TECHNICAL QUESTIONS AND RESPONSES TRACKING SHEET

36C77626B0011

Big Spring CLC Phase III Minor Construction
Project

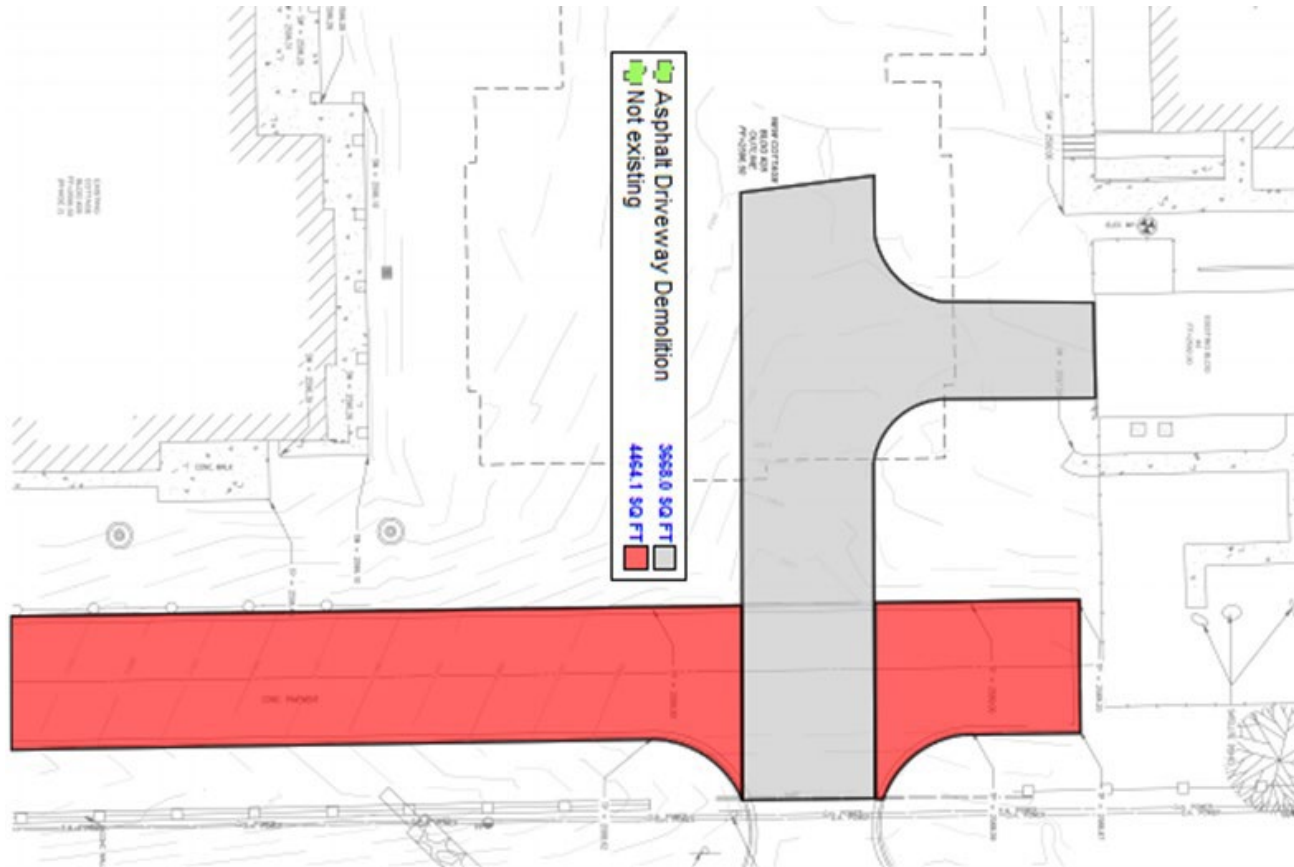
43	Document precedence language General notes indicate that in the event of a conflict, the more expensive, greater quality, and larger scope shall govern. Please confirm that contract interpretation will instead follow the applicable VA and FAR order-of-precedence requirements and not an open-ended "more expensive scope governs" standard for bid pricing purposes.	Confirmed that the contract interpretation will follow the applicable VA and FAR order-of-precedence requirements.
44	Medical gas manufacturers / basis of design The contract documents do not identify a basis-of-design manufacturer or an approved manufacturers list for the medical gas piping system components and alarm equipment. Please provide the acceptable manufacturers for medical gas system components, including outlets, valves, alarms, and source or system accessories, and confirm whether substitutions or equivalent products will be accepted in accordance with the specifications.	Refer to the VHA Directive 7515: Governs the safe operation, installation, and management of medical gas and vacuum utility systems and NFPA 99 Compliance: Mandatory adoption of healthcare facilities codes for oxygen, compressed air, nitrous oxide, nitrogen, and medical vacuum. Basis-of-design: Beacon-Medaes Alternate manufacturers include: Amico, Pattons Medical, Powerex Medical, Tri-Tech Medical

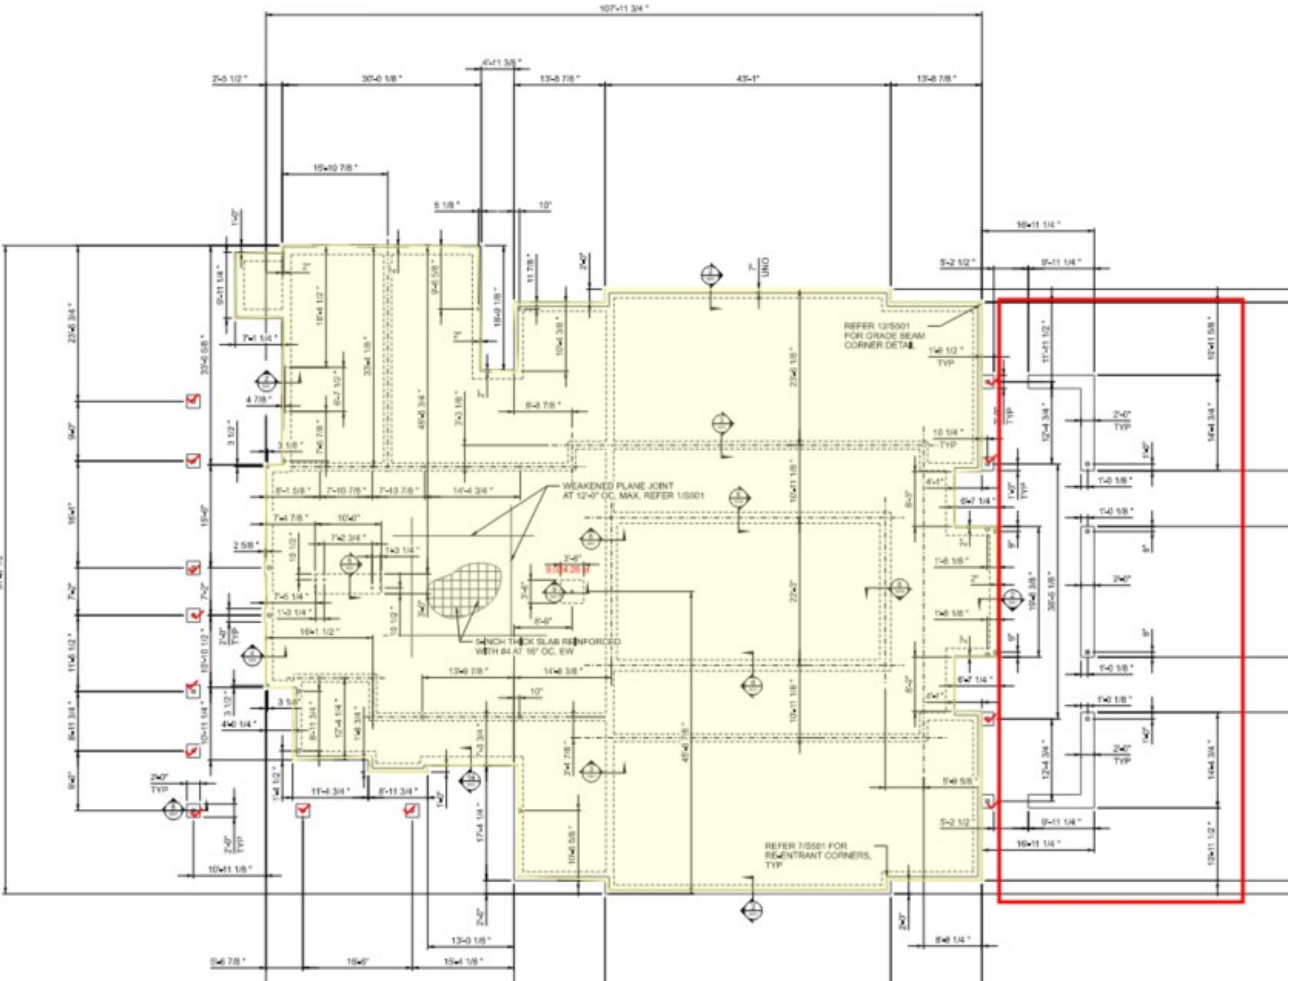
55 Existing asphalt driveway / demolition and phase scope clarification

During the site visit, an existing asphalt driveway was observed that does not appear to be clearly reflected in the demolition limits shown on the plans. In addition, the area identified as non-existing asphalt in red on the attached exhibit appears to conflict with existing field conditions. Please clarify whether the existing asphalt driveway is to be demolished under this phase of work, whether the red-marked area is included in this project scope, and what the exact asphalt demolition, removal, and reconstruction limits are for this phase.

The existing paving in gray was supposed to have been eliminated under a separate contract in advance, but that contract was not awarded. For bidding purposes, contractor should anticipate saw cutting and removing all existing paving within at least 5 feet of the building or any other elements of the site to be installed under this contract.

Similarly, the paving in red was planned to be constructed under a separate contract. For purposes of bid, ignore that paving as shown in the site plan.
